## Development Review Division

### MEMORANDUM

**SUBJECT:** SP20-081 New Horizon Daycare Site Plan – Planning Review 1

SITE PLANS FOR NEW HORIZON ACADEMY

COVER SHEET

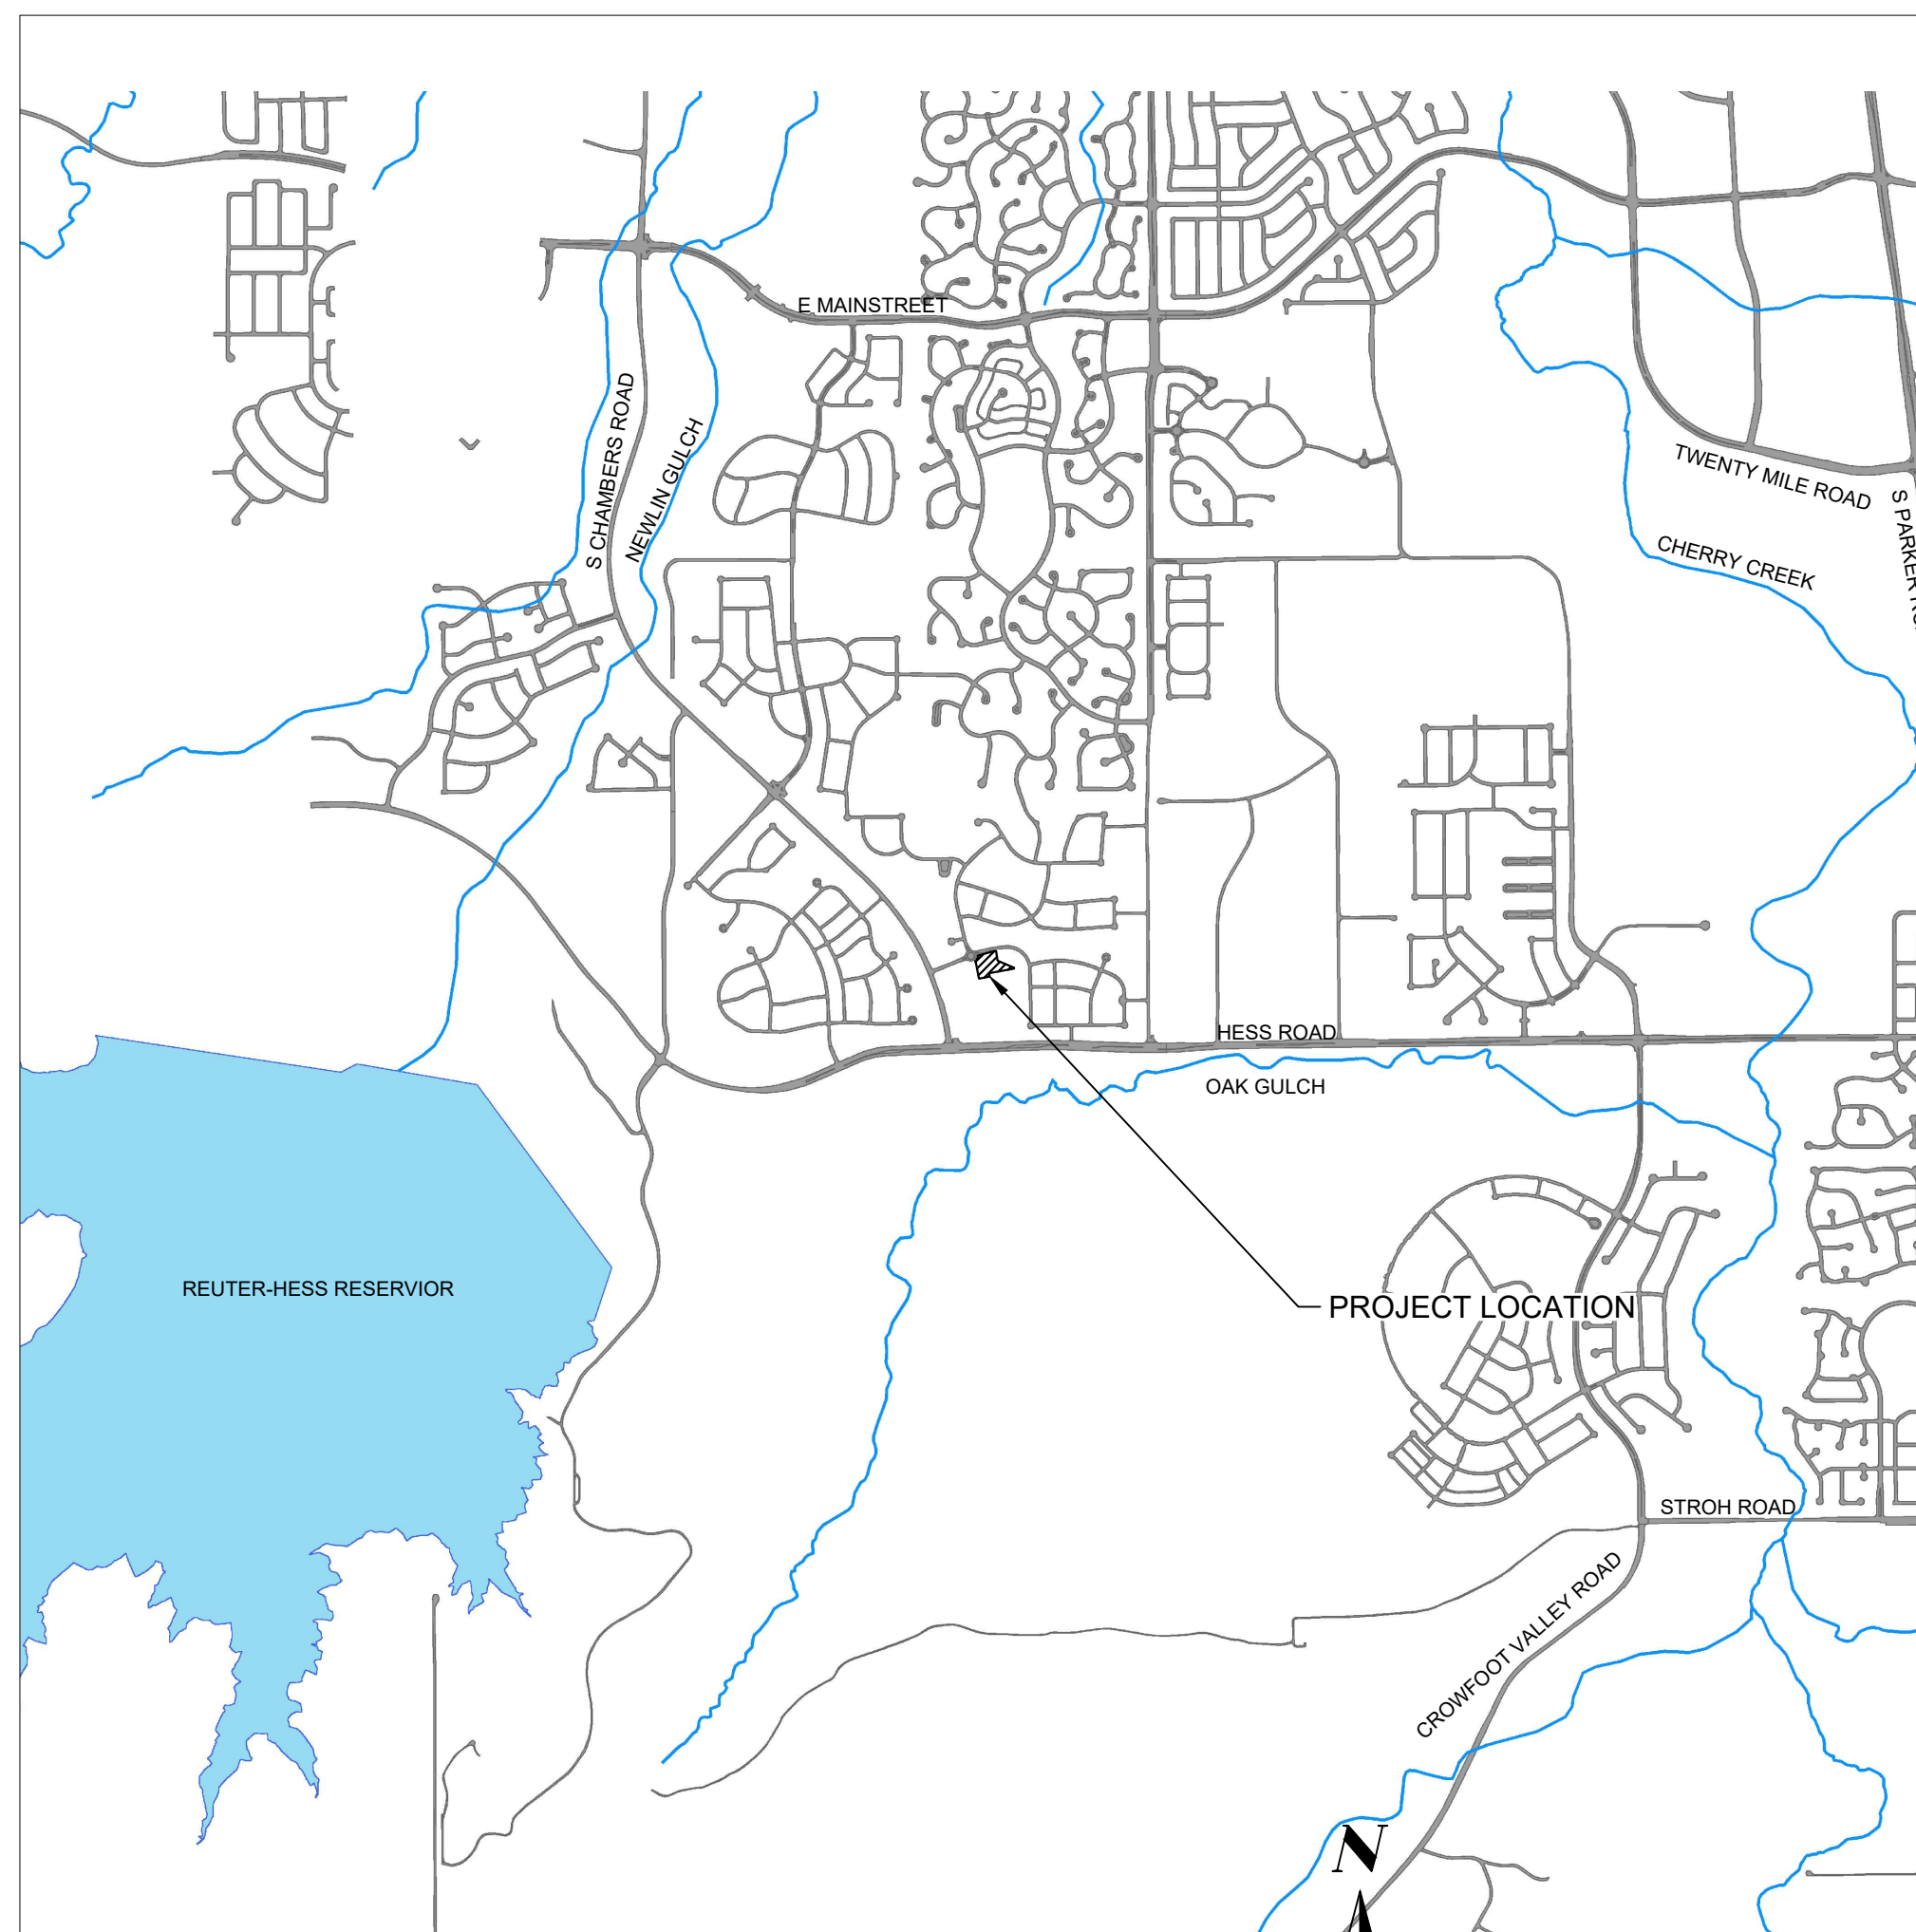
On second submittal include the playground plans in with the site plan set.

Add this note to cover page per LDO 13.16.050 (M) A plan note stating that all mechanical equipment shall be screened from view from a public right of way. Final location and screening measures shall be determined at time of final site plan under Chapter 13.06 of this Title.

Add space on sheet for legal description.

remove on every page this appears

OVERALL SITE

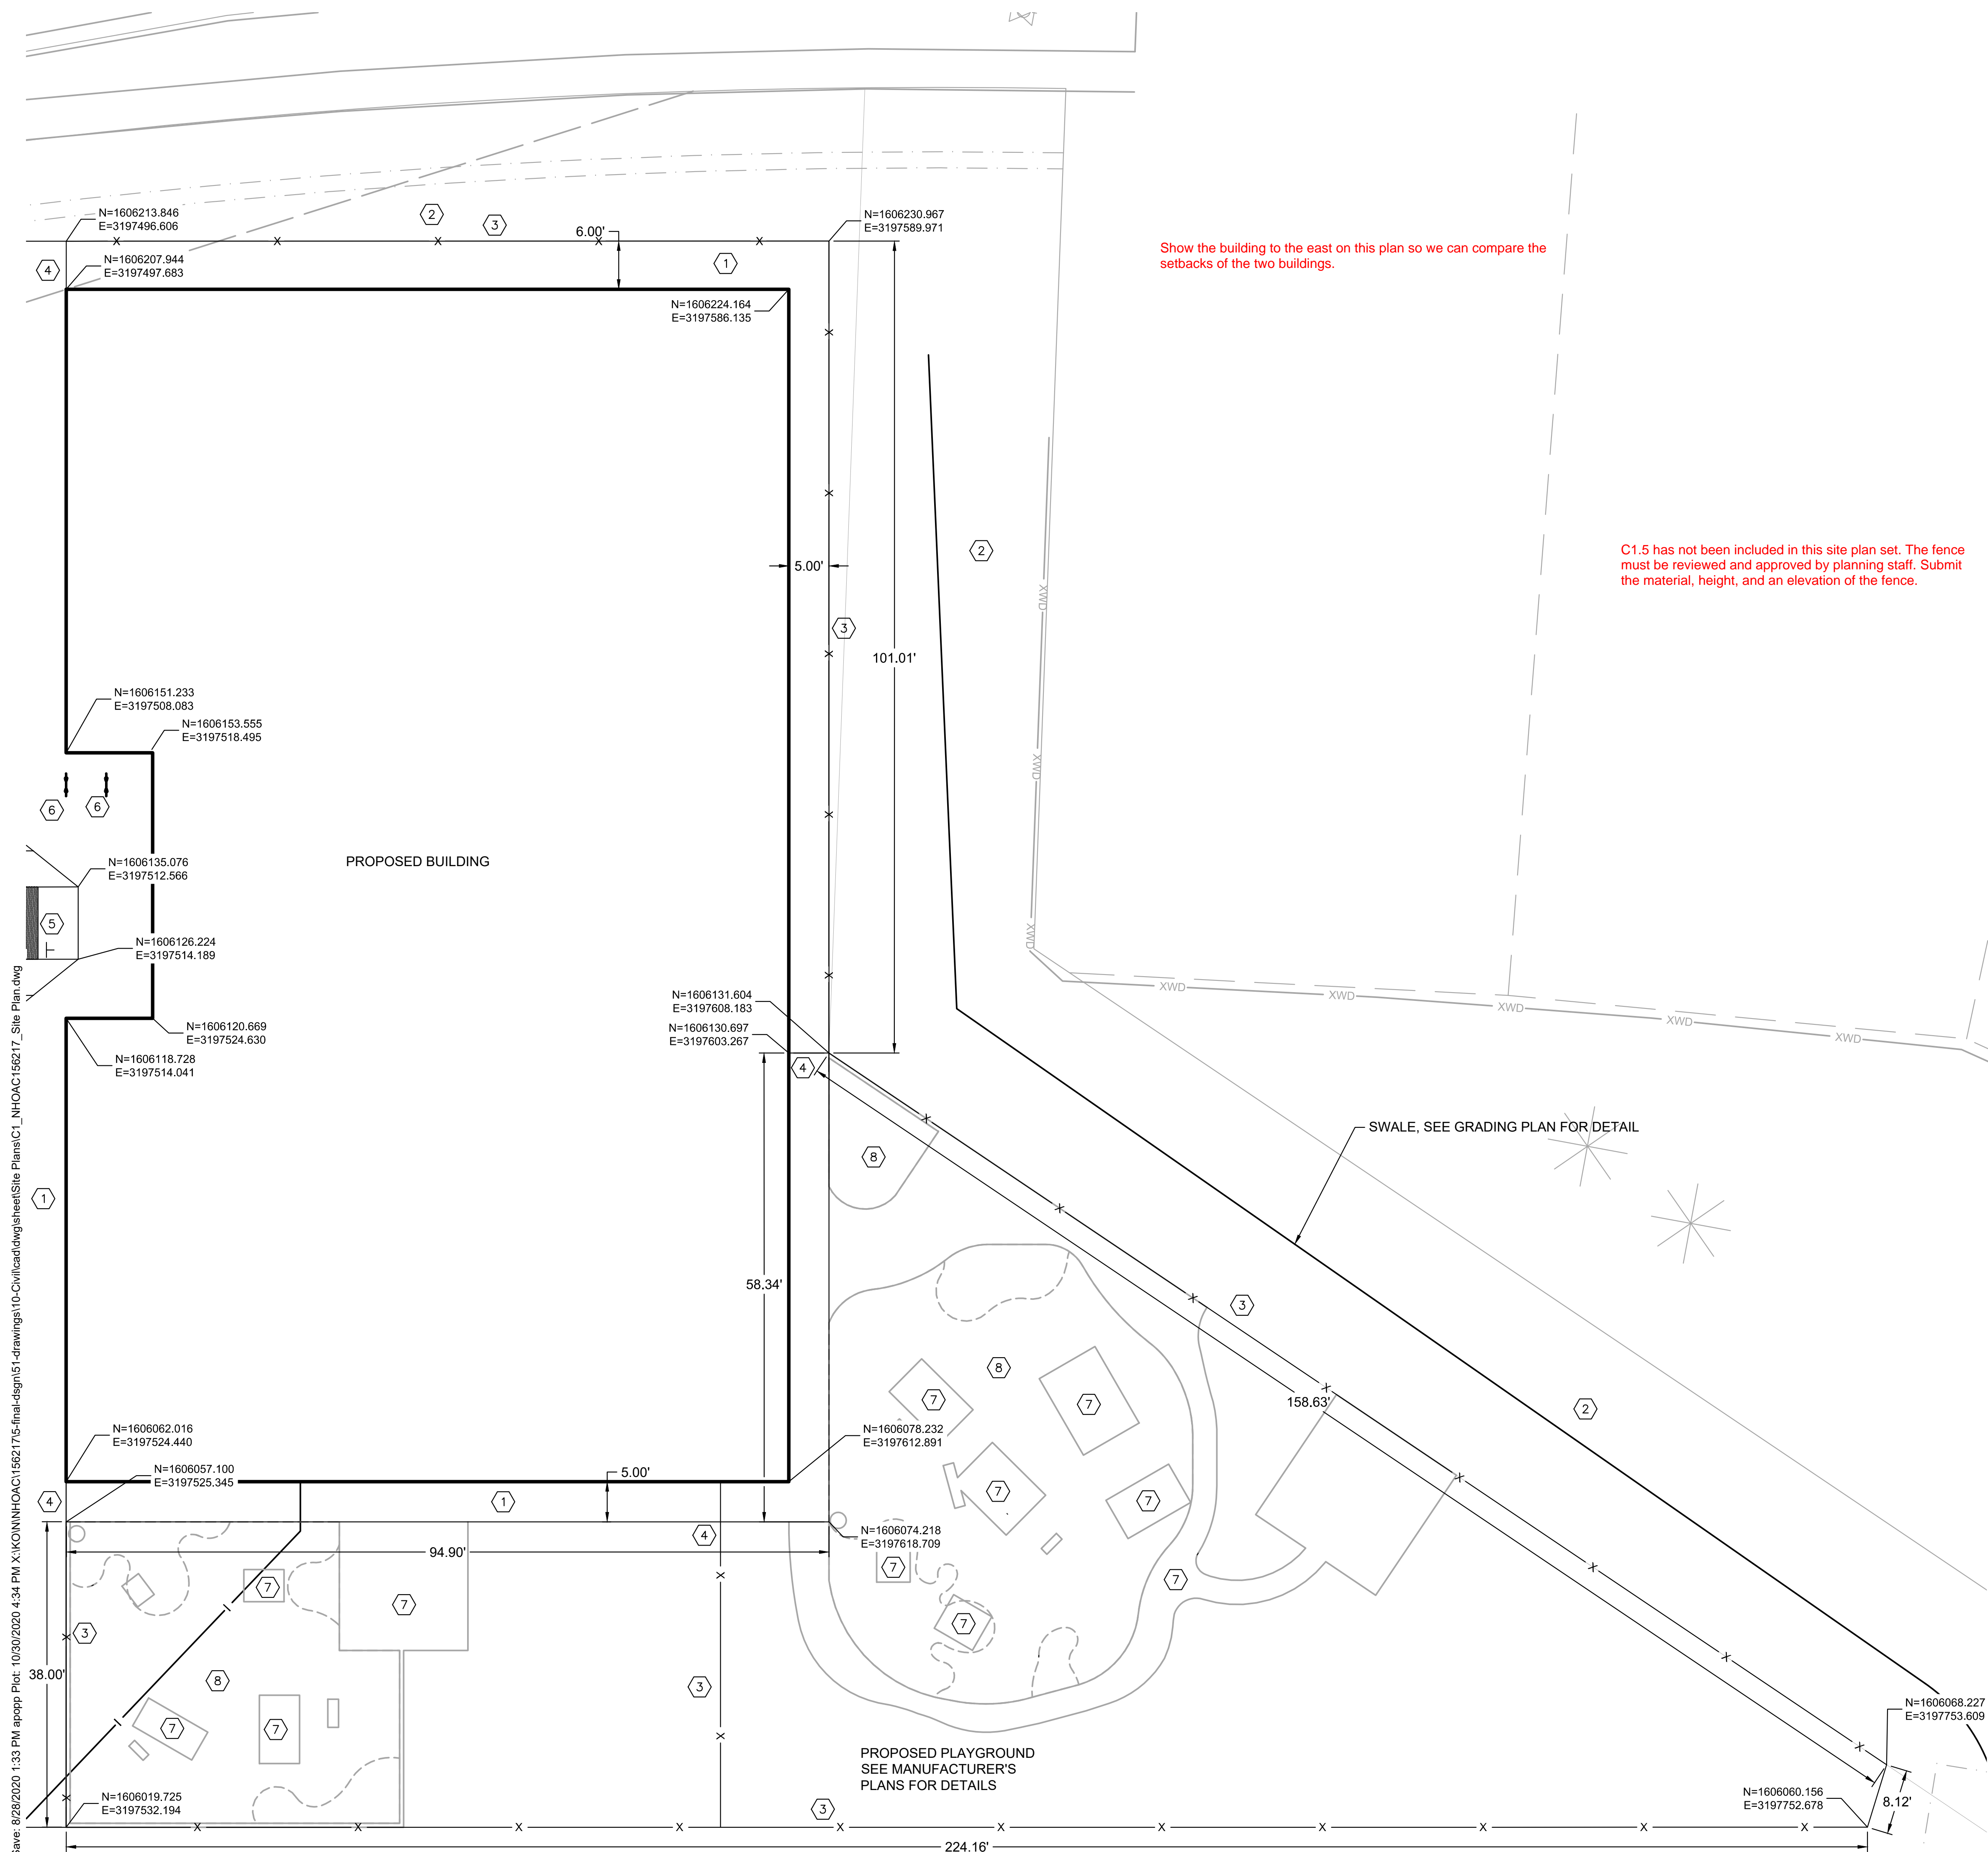
Draw setbacks on plan, and easements. label ALL. include line legend for relevant line styles used on EACH page.  
Include dimensions of all elements, including facade length, and square foot area of all elements.

what is the sq ft area of the parking lot?

Please call out the SQ Ft of playground area. It looks like you are including this in your open 'landscaping' area.

Identify child capacity, necessary to determine parking ratio.

Show sidewalks in a different line style for better visibility.

PARKING LOT SITE LAYOUT

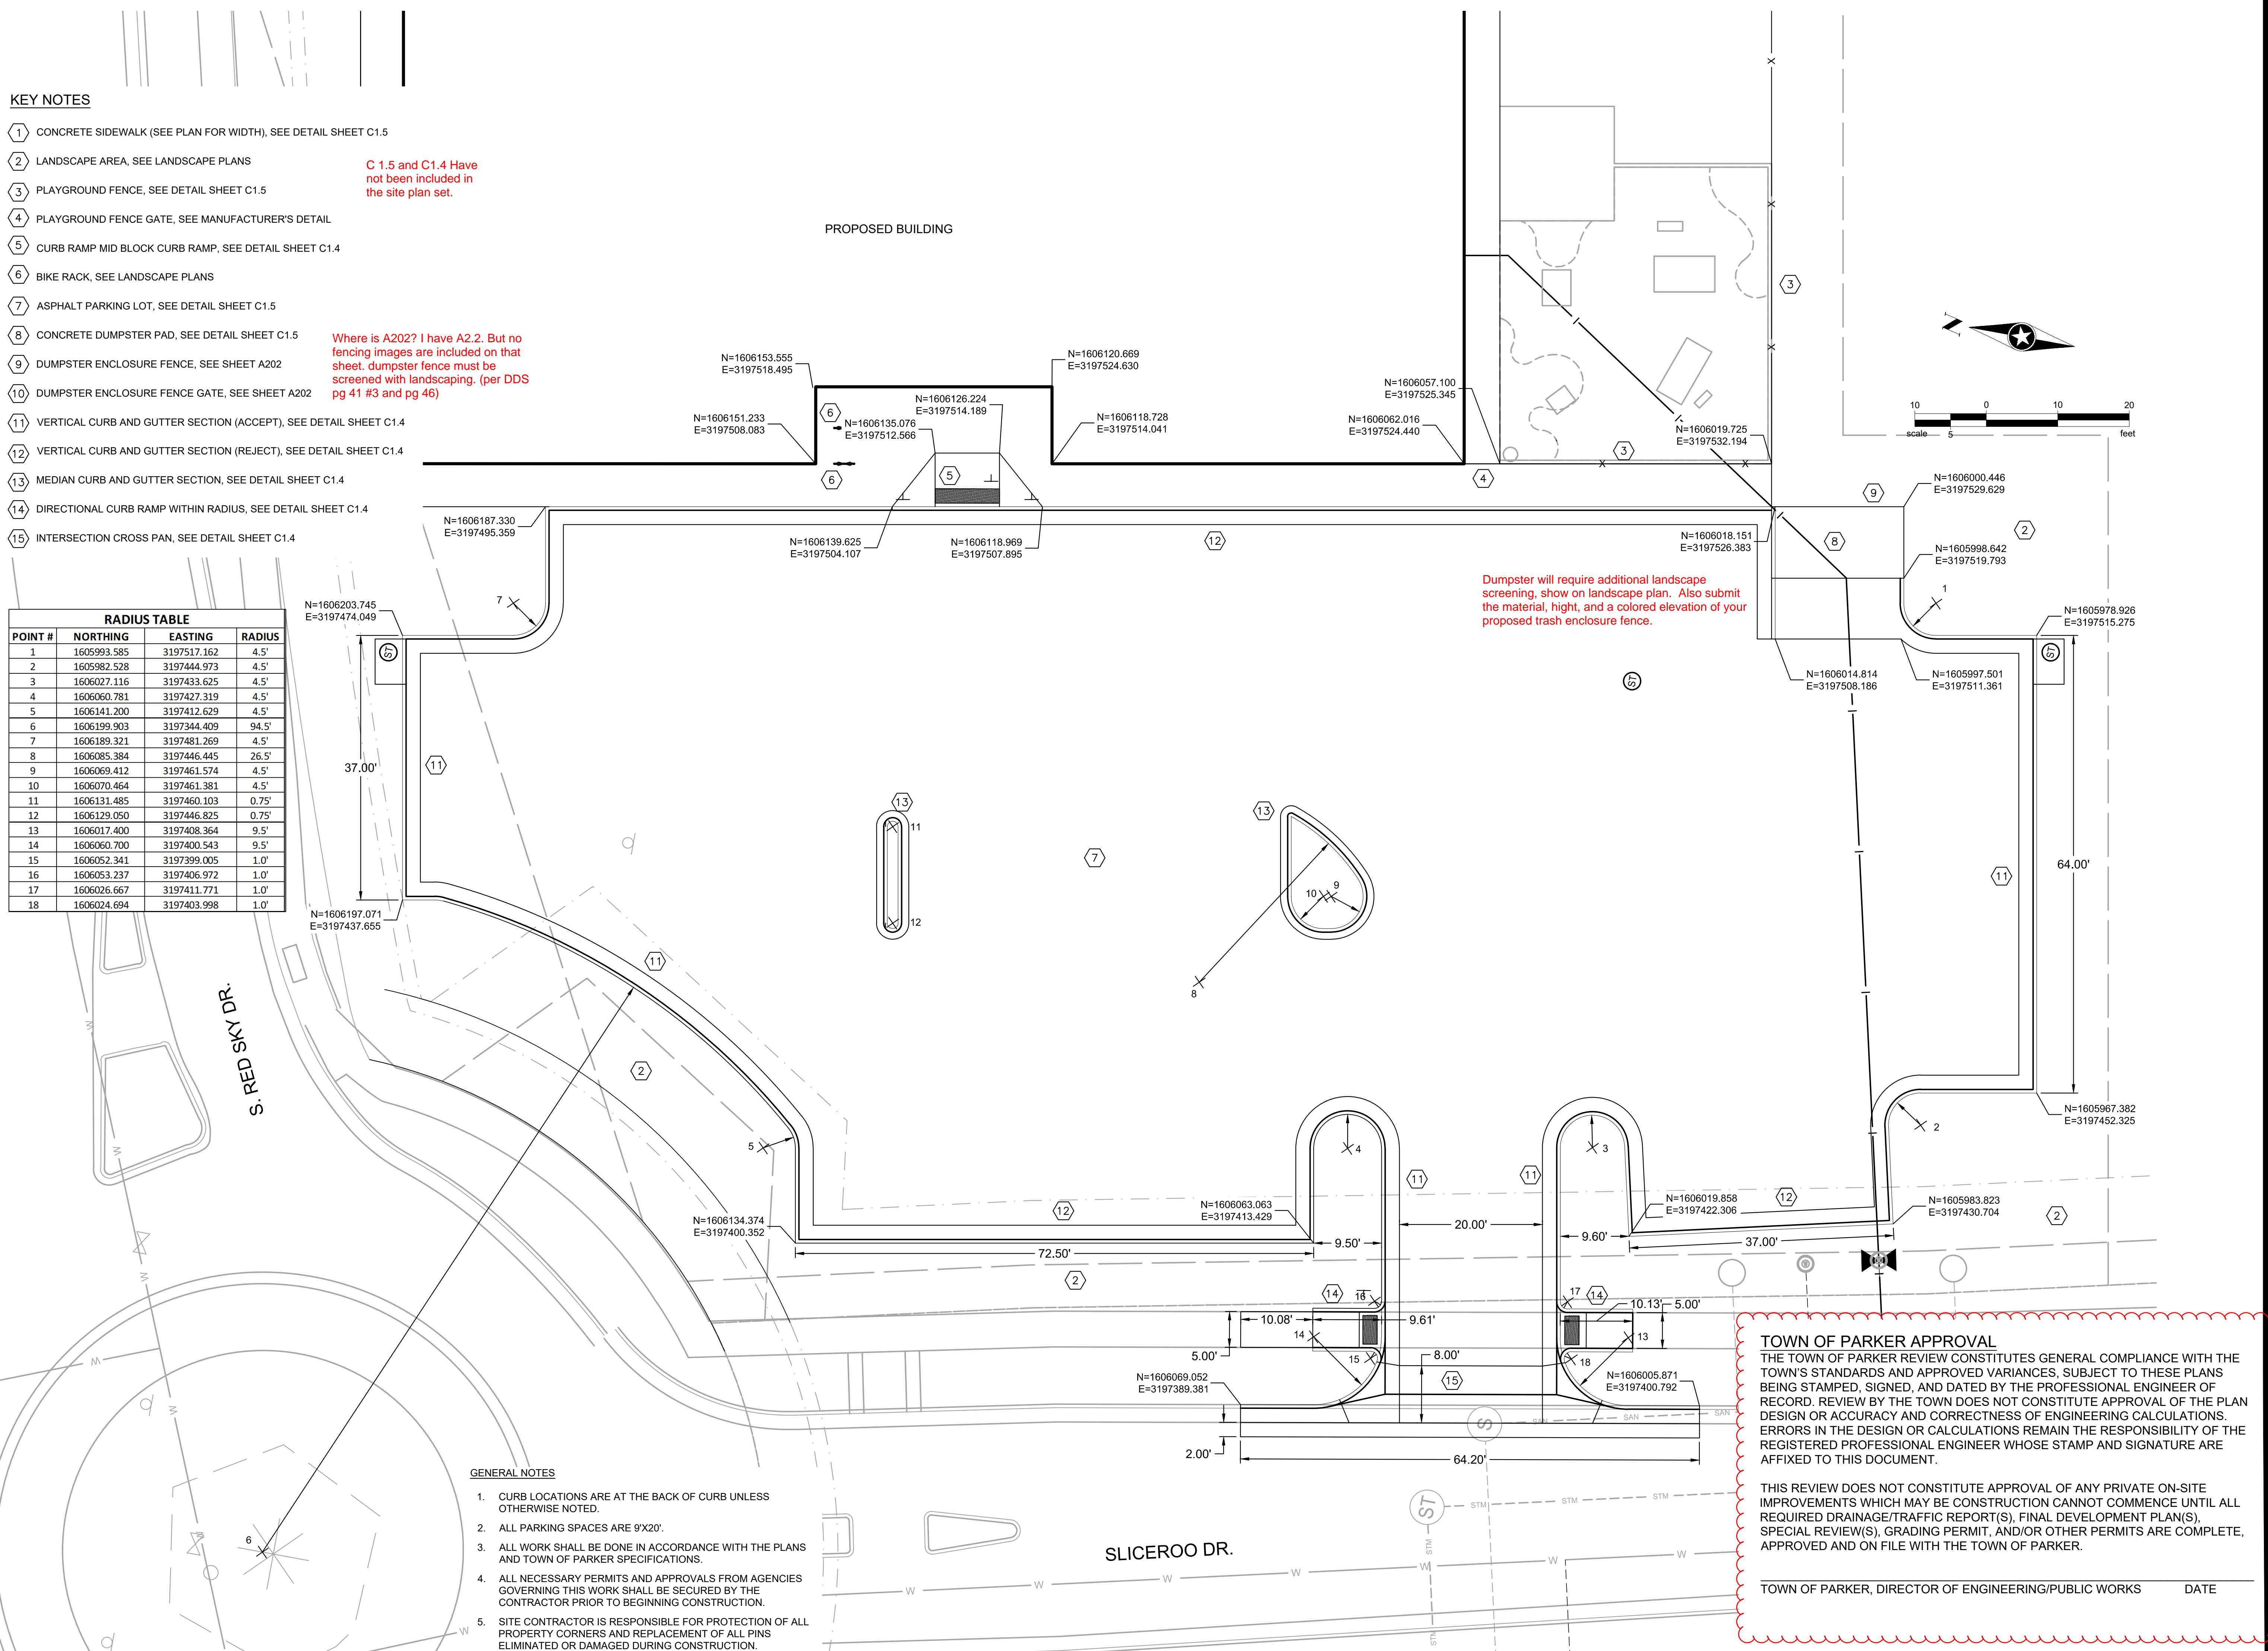
C 1.5 and C1.4 Have not been included in the site plan set.

Where is A202? I have A2.2. But no fencing images are included on that sheet. dumpster fence must be screened with landscaping. (per DDS pg 41 #3 and pg 46)

Dumpster will require additional landscape screening, show on landscape plan. Also submit the material, height, and a colored elevation of your proposed trash enclosure fence.
